Russel Garments (Unit-2)

22 April 2014

Observations

Staircore to North Elevation

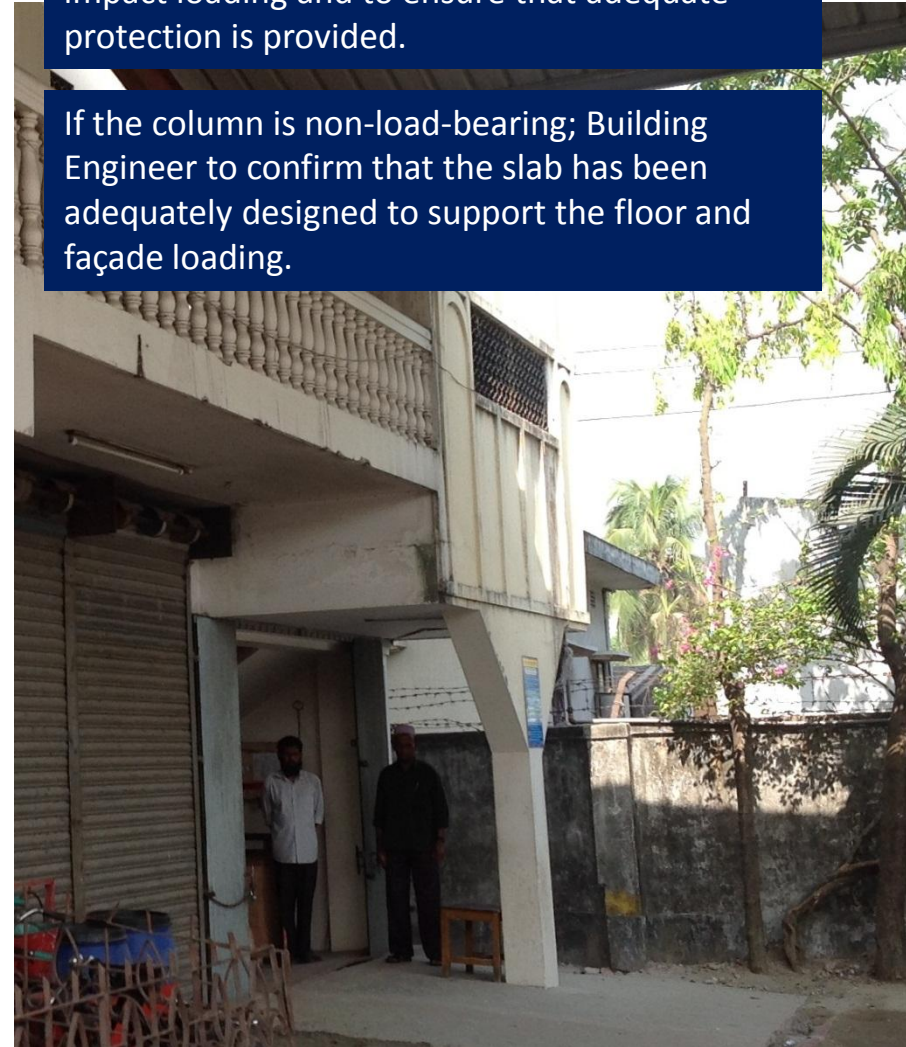
Single column observed at Ground Floor level to the underside of the protruding landing of the North Staircore.

The column is not shown on the drawings. It is not clear whether this column is structural, or whether the slab cantilevers.

If column is structural ; Building Engineer to confirm if the column has been designed for impact loading and to ensure that adequate protection is provided.

If the column is non-load-bearing; Building Engineer to confirm that the slab has been adequately designed to support the floor and façade loading.

South Staircore to West Elevation

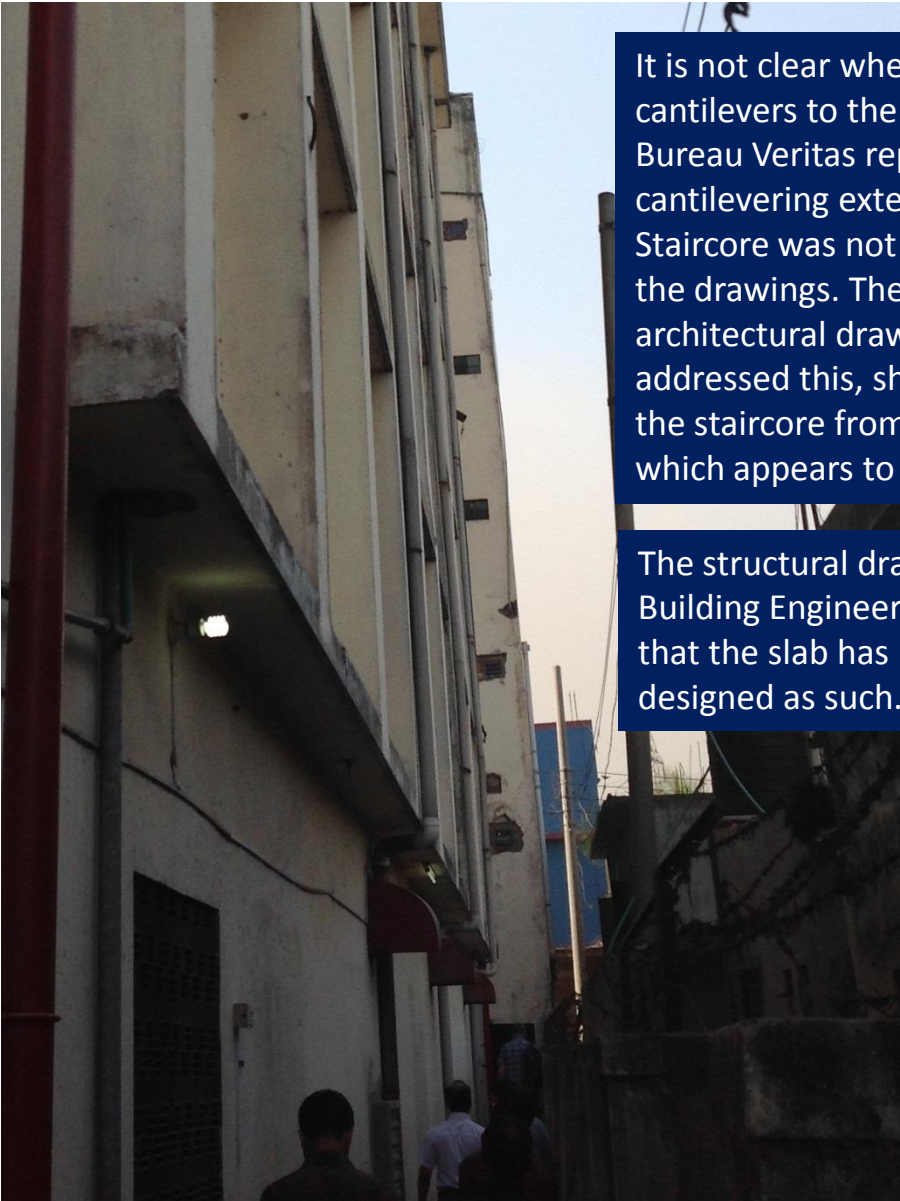
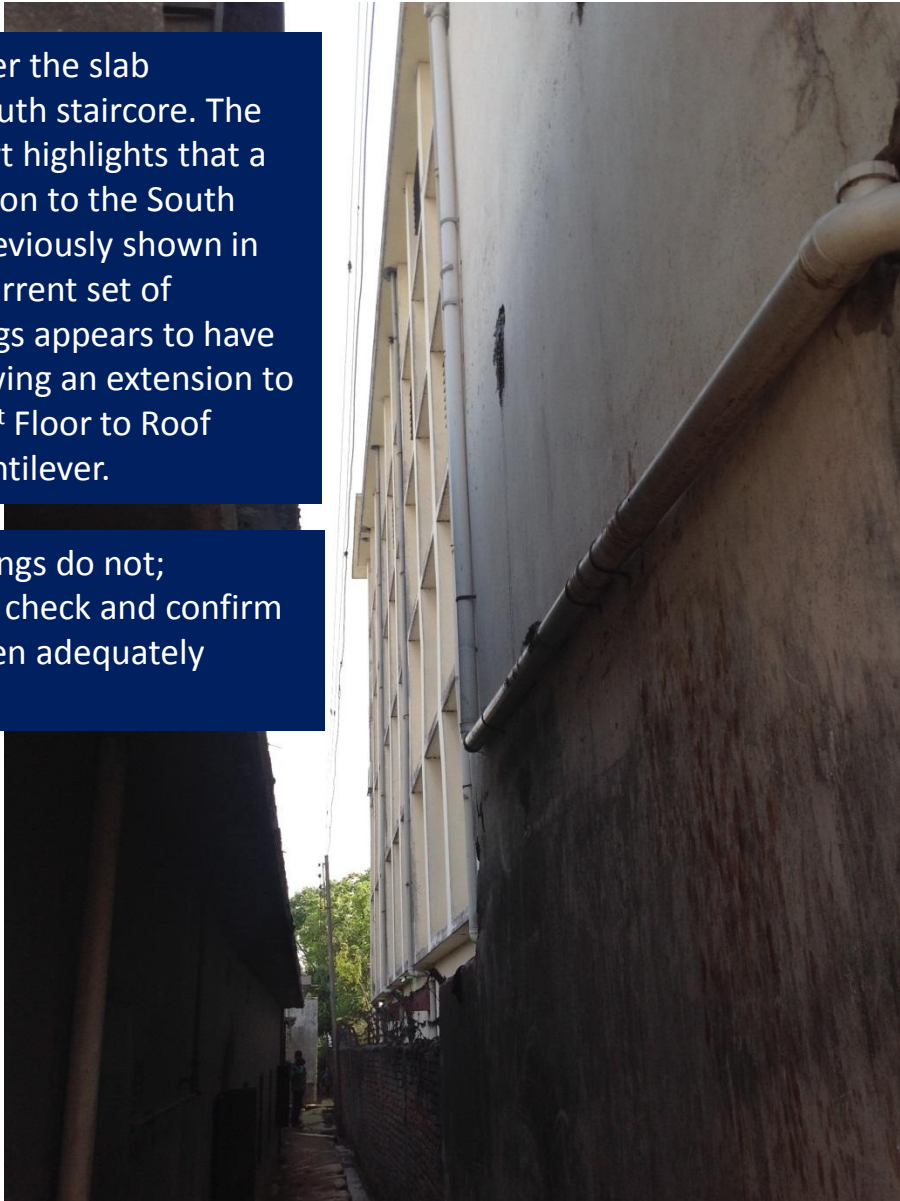
It is not clear whether the slab cantilevers to the South staircore. The Bureau Veritas report highlights that a cantilevering extension to the South Staircore was not previously shown in the drawings. The current set of architectural drawings appears to have addressed this, showing an extension to the staircore from 1st Floor to Roof which appears to cantilever.

The structural drawings do not; Building Engineer to check and confirm that the slab has been adequately designed as such.

Extension appears to be supported on perimeter wall

Possible 800mm Build-up (Average) in Toilet Area to South Staircore Half-Landing to all Floors

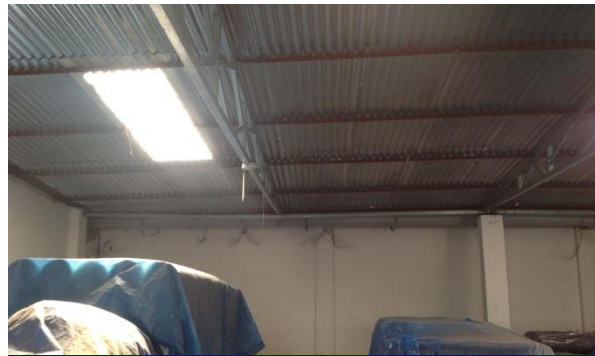
Areas of high loading were noted at the water tanks at Roof level, at the Finished Goods Storage area at 4th Floor level, and at the toilets at all floors, as well as at the 3rd Floor level storage area to the 4-storey building. Building Engineer to check that the different slab constructions have been adequately designed to accommodate this loading, and to develop a factory floor loading plan to include maximum floor loading capacities for each floor.

Deflection of Cross-Beams

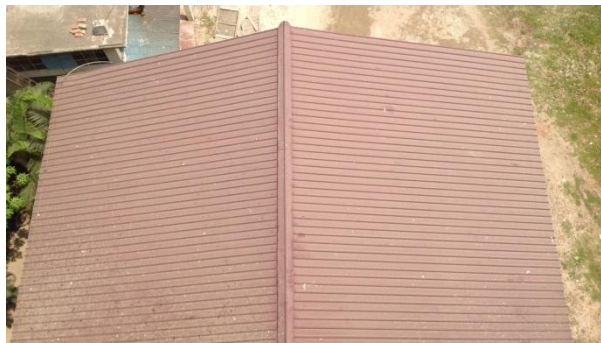
The Godown Warehouse, comprising a lightweight steel-trussed roof on RC columns, does not appear to be engineered. The cross beams are deflecting excessively, there is no horizontal bracing to the roof, and the connections do not appear adequate. Similarly, the Entrance Canopy to the Main Factory Building, a lightweight steel structure, lacks adequate bracing. Building Engineer to review the design of these lightweight structures for lateral and uplift loading, and to implement any upgrade works as required.

- Building Engineer to check the design and capacity of the lightweight steel structures/connection details as part of the Detailed Engineering Assessment and make any necessary alterations.

Item 3 and actions

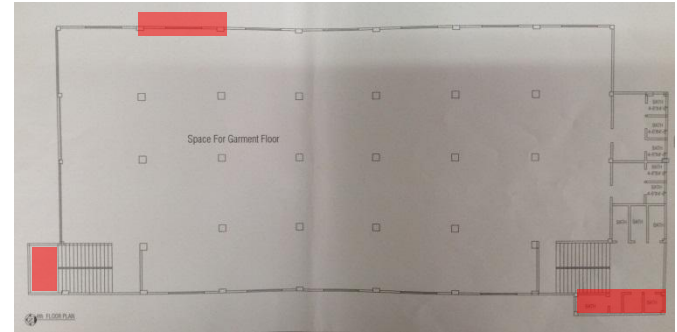
Cantilevered areas but with ground floor column or boundary wall appearing to carry load; vertical loadpath needs clarification

- As part of the Detail Engineering Assessment. The Building Engineer is to review the projecting areas of slabs to check if the slabs are cantilevered or there is an adequate vertical load path.
